# Access Compliance Report

## Public Rights-of-Way

Intersection ID: 2928	Main Street: PROSPERITY_CHURCH_RD	Cross Street: RIDGE_RD	Location: SE
ADA ID: 9BE515805C7F	Ramp Type: Perp	Initial Pass/Fail: Fail	Overall Compliance: No
Severity Score: 35			
Codes/Mitigation Info/Possible Solution		Field Measurements/Component Compliance

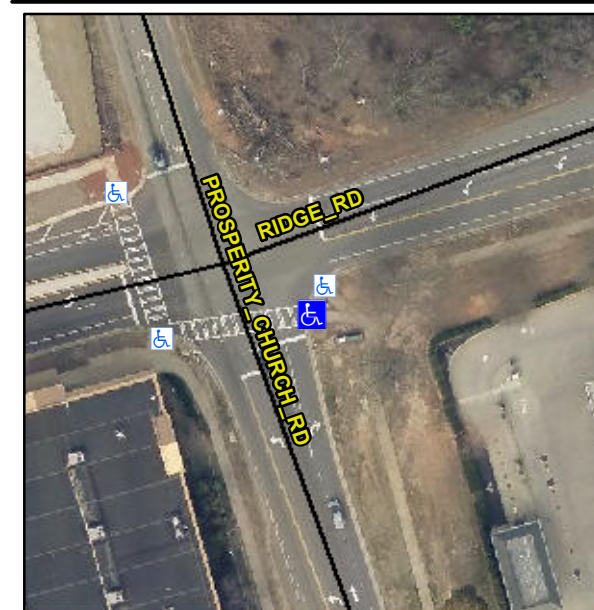
**Remove & Replace Entire Ramp.**

**R304.5.1, R304.5.3**

Compliance	Description	Data	Compliance	Description	Data
N/A	Ramp Length (in)	186.0	Yes	Ramp Slope (%)	15.7
No	Ramp Width (in)	47.5	No	Ramp XSlope (%)	2.4
N/A	Flare Type LT	N/A	N/A	Flare Type RT	N/A
N/A	Flare Slope LT (%)	N/A	N/A	Flare Slope RT (%)	N/A
N/A	Flare Traversable LT?	N/A	N/A	Flare Traversable RT?	N/A
N/A	Landing Length (in)	N/A	N/A	DWS Provided?	N/A
N/A	Landing Width (in)	N/A	N/A	DWS Contrast?	N/A
N/A	Landing Slope (%)	N/A	N/A	DWS Length (in)	N/A
N/A	Landing X Slope (%)	N/A	N/A	DWS Full Width?	N/A
N/A	Landing Curb? (Y/N)	N/A	N/A	DWS Offset (in)	N/A
N/A	Shared Landing?	N/A			
N/A	Gutter Ponding?	N/A	N/A	Gutter Slope (%)	N/A
N/A	Gutter Lip Ht (in)	N/A	N/A	Gutter X Slope (%)	N/A
N/A	Painted X Walk1?	Yes	N/A	Painted X Walk2?	N/A
	X Walk 1 Direction	To W		X Walk 2 Direction	N/A
N/A	X Walk 1 Width (in)	115.0	N/A	X Walk 2 Width (in)	N/A
	X Walk 1 Slope (%)	5.4		X Walk 2 Slope (%)	N/A
	X Walk 1 X Slope (%)	1.4		X Walk 2 X Slope (%)	N/A
